**ONSITE SEWAGE DISPOSAL SYSTEM**

P 545033

PROPERTY ADDRESS: 13301 ROYDEN COURT, ELICOTT CITY, MD 21042

Site plan  
Lot 25 R  
5th. Election

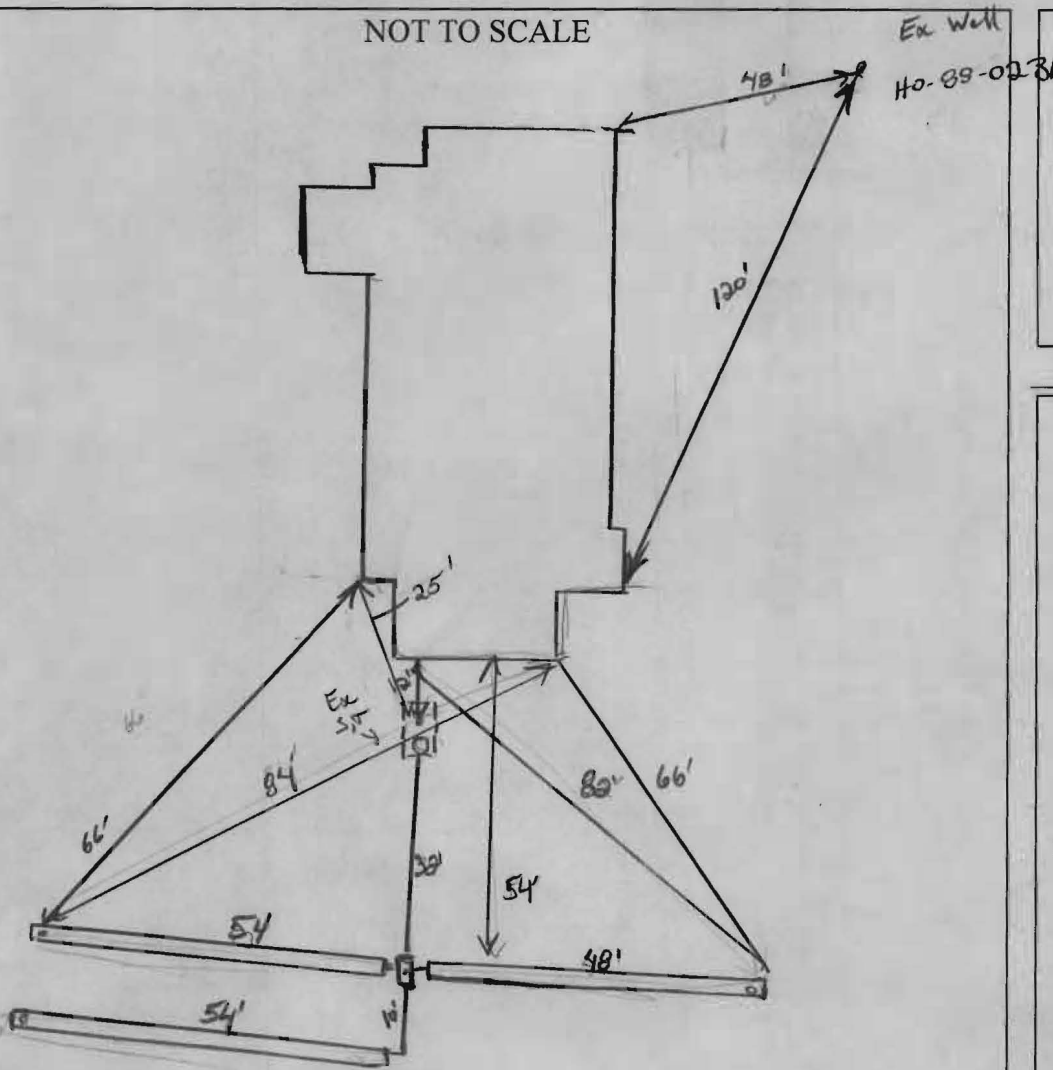
5/17/13 Existing system dug up. Installed on contour but great deal of sludge buildup in dist. box and trenches. Homeowner explained he had a pumped tank. Set new dbox just below ex. lower trench install 2x50 trenches running west along property and 1x60' trench running east along property. obs. pipes required in trenches. Manhole riser to be added on existing tank. KW

5/20/13 Trenches installed. Did not make 60' trench. Not sure why. Trench was pointed out for 60'. 2x50' trenches lengthened since. Homeowner notified. Need speedy levelers. KW 5/21/13 Speedy-kicks installed in Dbox. System complete. KW
